Peer Review of the HB02 Pump Test (October, 2009) and the PB Report  
“Broke Groundwater Investigation and Monitoring Report - AGL Hunter  
Gas Project”.

**DRAFT FOR DISCUSSION AT 24 MARCH 2010 BCCC MEETING**

Professor Garry Willgoose  
24 March 2010

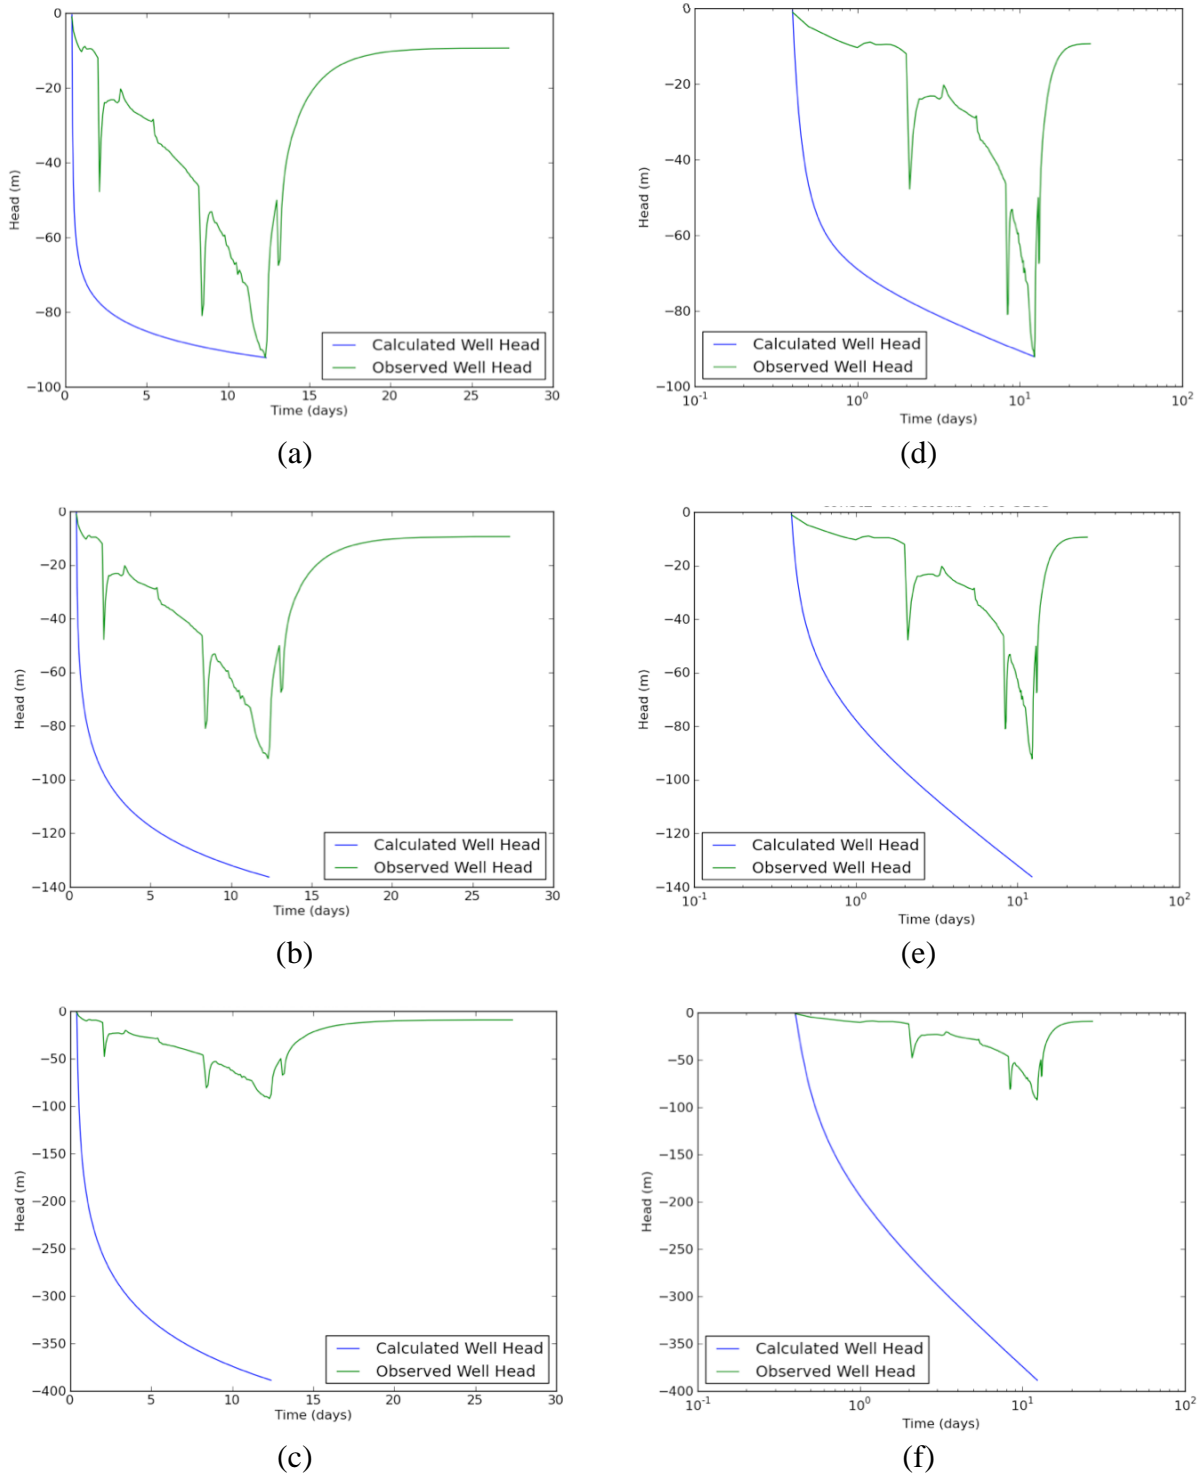
The first set of simulations used the 3 conductivities as derived by PB in their Table 6.5 and listed in Table A2. The pumping rate was the pumping rate for the period of the pump test for which the conductivities were derived. The time period listed in Table A2 is the simulation time used in the all of the figures below, which are relative to the start of the pump test. The results are shown in Figure A1.

The reader is cautioned that it is not expected that these results will fit the pump test data (also plotted in the Figures) because the simulations do not use the actual pumping rates (that change in time through the test). The figures are provided simply to show the rate at which convergence to asymptotic behaviour (i.e. linearity on the semi-log plot in Figure A1) occurs. It is clear that that in all cases it is several days, and in cases longer than the period over which the three conductivities are derived. This impacts on the conductivities derived by PB analysis, as it means that one of the assumptions of the Jacob method is invalidated. Finally, the asymptotic slopes of the 3 computer simulated drawdown curves are the same as the slopes of the regions of the pump test from which the conductivities were derived. This confirms that the computer code is yielding correct results given the conductivities used in the modelling.

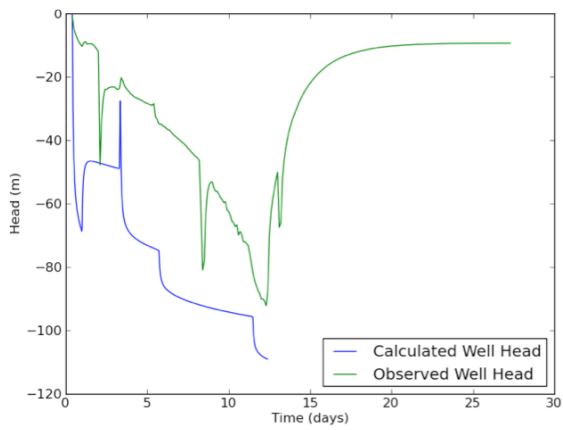
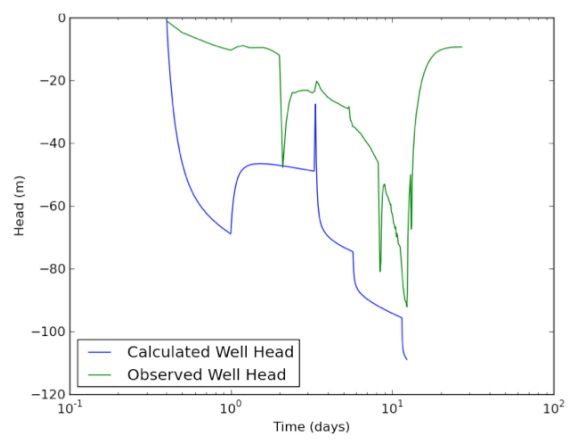
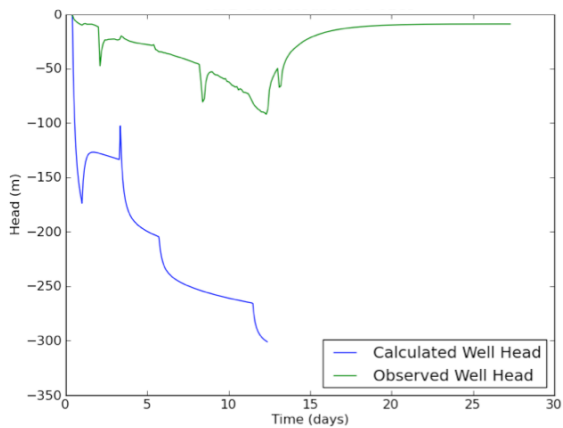
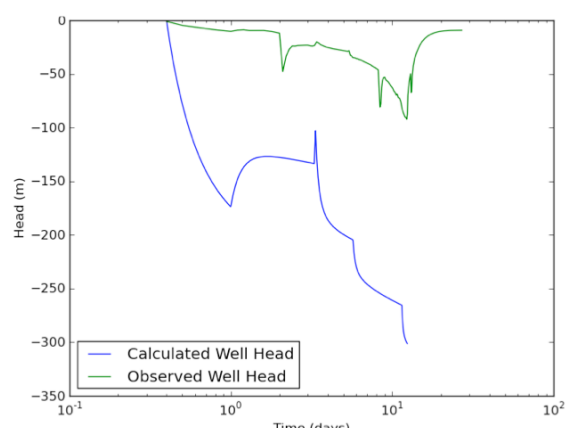
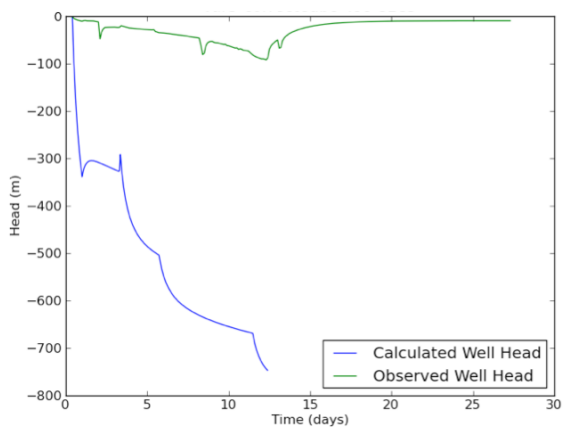
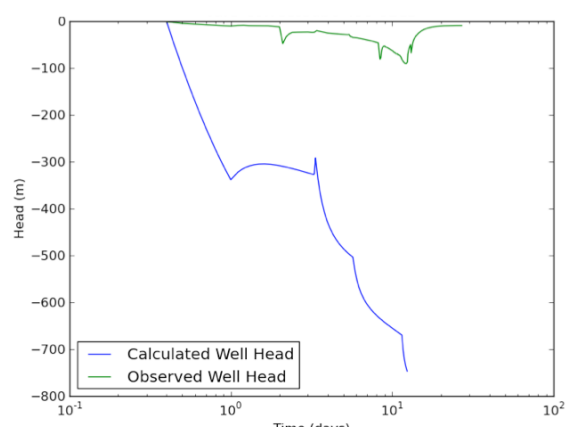
of the conductivities provide a good fit to the data and in the following sections explore some alternative conductivity cases will be explored. The poor results in Figure A2 confirm that the aquifer conductivity is not constant in space.

However, one important conclusion is consistent with the PB interpretation of the time trend of the pump test. As the pump test proceeds the observed rate of well drawdown steepens (i.e., the drawdown curve gets steeper with time, particularly obvious in Figure A2d-f). Figures A1 and A2 show that this steepening is unlikely to be a result of the increasing pumping rate during the test because the model does not show a similar trend. Rather it is likely to be a result of a decreasing conductivity of the aquifer with distance from the well. This supports the conclusions in the PB report that, even though they misapplied the Jacob method (and thus their conductivity estimates are likely to be inaccurate so their conductivities are likely to be too low), their conclusion that the aquifer conductivity decreases with distance from the well is likely to be correct.

**Figure A3:** The best fit parameters for the first 5 days of the pump test (a) the PB conductivity  $K=0.043\text{m/day}$  (b) a sensitivity study with  $K=0.08\text{m/day}$

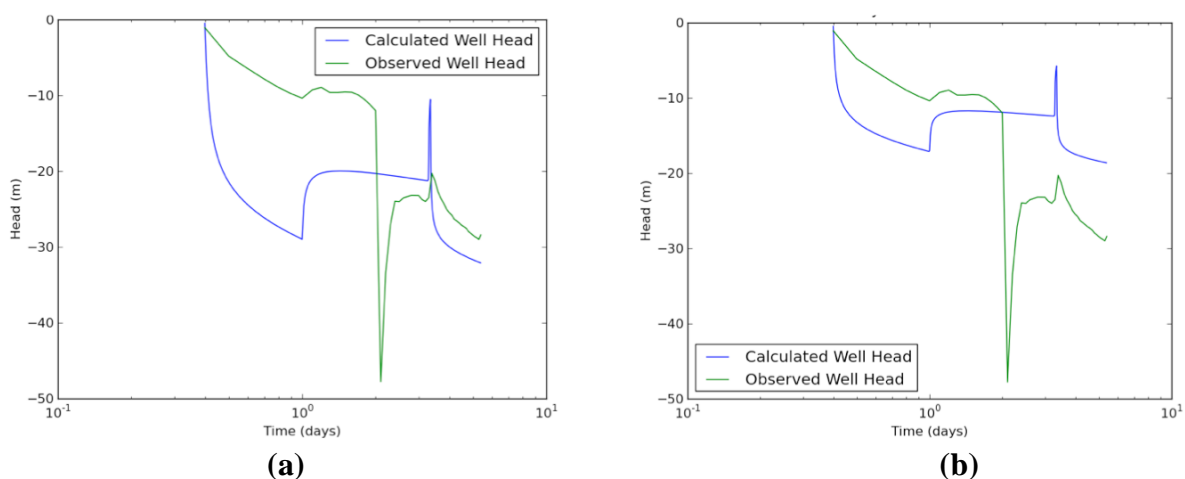
The parameters fit by PB to the first day of the drawdown do provide the best fit to the first 5 days of the data (Figure A3). The initial amount of drawdown is too large, but this is function of the storativity not the conductivity. The match in conductivity is indicated by the match between the slopes of the data and model results. Figure A3 also shows a result for a slightly higher conductivity of  $K=0.08\text{m/day}$ , which shows the sensitivity to a change in conductivity. The initial drawdown is less but the rate of subsequent drawdown is too low.

**Figure A4:** Best spatially variable conductivity (a) (b)  $K=0.08\text{m/day}$  at well, (c) (d)  $K=0.043\text{ m/day}$  at well.

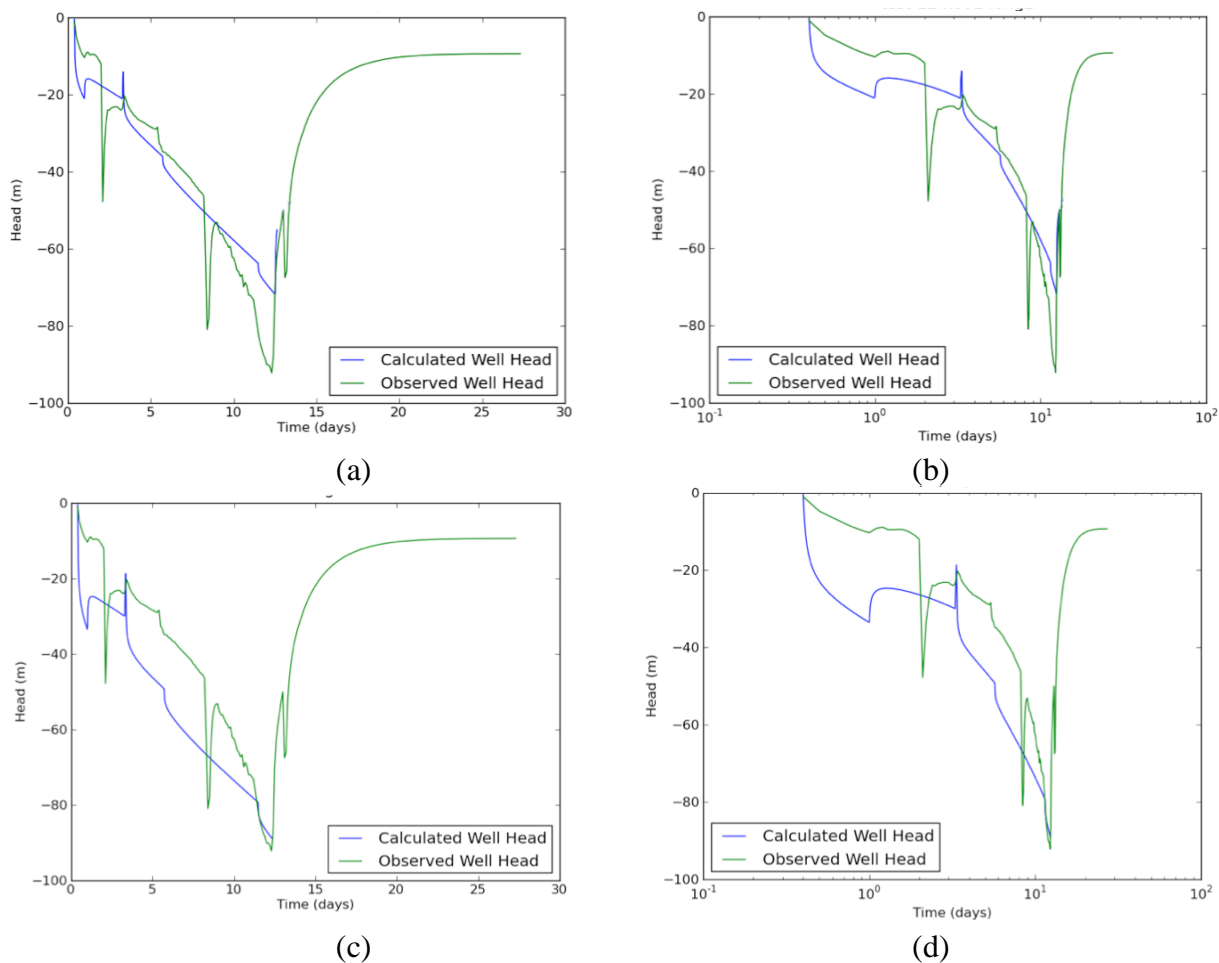
Accordingly a number of configurations for the spatial variation in conductivity were investigated. It was not possible to obtain a good fit to the overall drawdown if the initial conductivity of  $K=0.043\text{m/day}$  was used but good fits were obtained with an initial conductivity of  $K=0.08\text{m/day}$  (Figure A4).

The result in Figure A4 uses a linear drop in conductivity with distance from the well. The conductivity at the well is  $0.08\text{ m/day}$ , dropping down to  $0.005\text{ m/day}$  at  $10\text{m}$  and dropping to  $0.001\text{m/day}$  at  $12\text{m}$  and then  $0.0001\text{ m/day}$  at  $18\text{m}$  and further out. This suggests that as the
